DART SERVICE INSTRUCTION

TO AMEND DRAWING D350-607 REV. F

REF CANADIAN STC: SH94-14

FAA STC: SR00213NY

FIGURE 1 - D2732-030 RUBBER CUSHION INSTALLATION
(4 PLACES PER INSTALLATION)

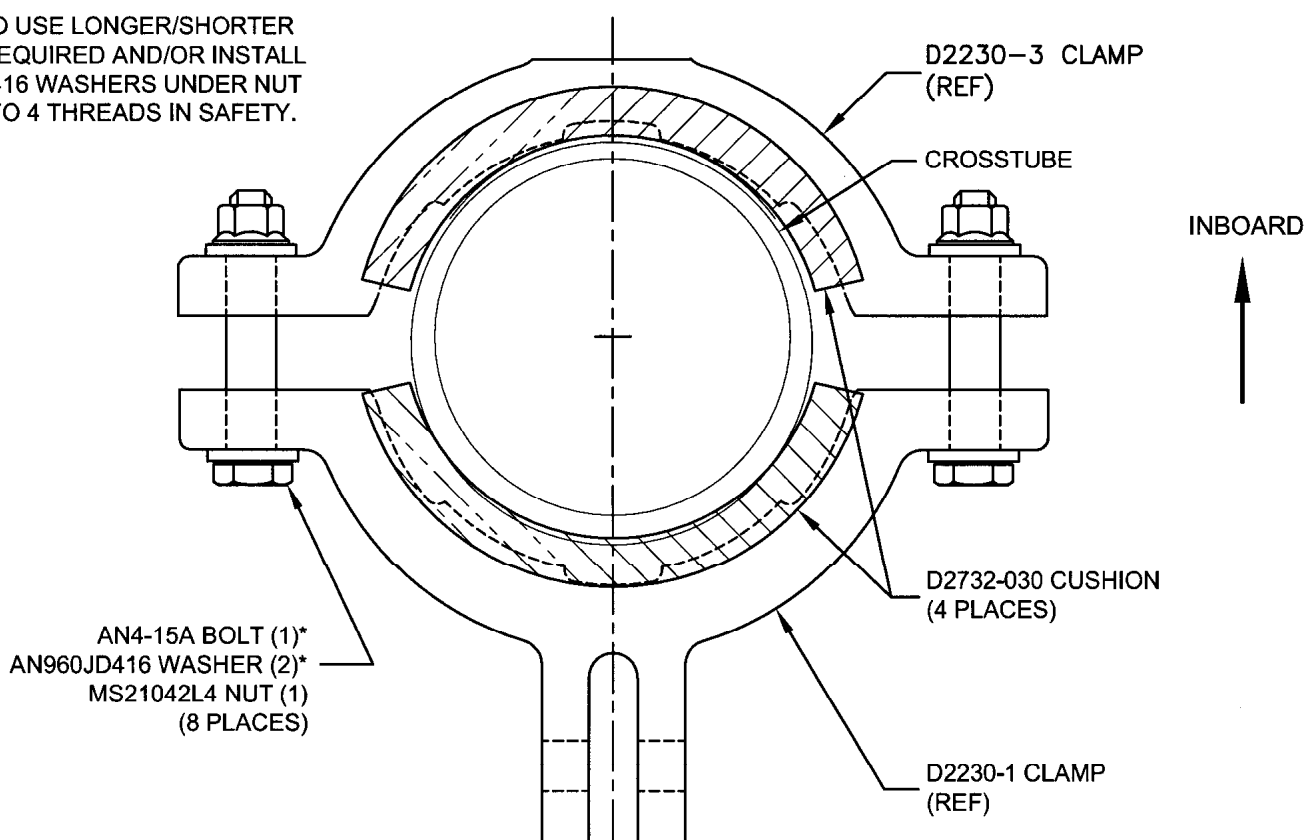
FOR THE FOLLOWING D350-607-XXX HELI-UTILITY-BASKET INSTALLATIONS, INSTALL THE D2732-030 RUBBER CUSHIONS UNDER THE D2230-1/-3 CLAMPS AS SHOWN IN FIGURE 1. THE D2856-400-720 ABRASION STRIPS HAVE BEEN REMOVED FROM THE D350-607-XXX HELI-UTILITY-BASKET KITS.

NOTE: REMOVE THE D2856-400-720 ABRASION STRIP PER SECTION 25.5 OF ICA-D350-607 PRIOR TO INSTALLING THE D2230-1/-3 CLAMPS WITH THE D2732-030 RUBBER CUSHIONS.

*ACCEPTABLE TO USE LONGER/SHORTER AN4 BOLTS AS REQUIRED AND/OR INSTALL EXTRA AN960JD416 WASHERS UNDER NUT TO ENSURE 1.5 TO 4 THREADS IN SAFETY.
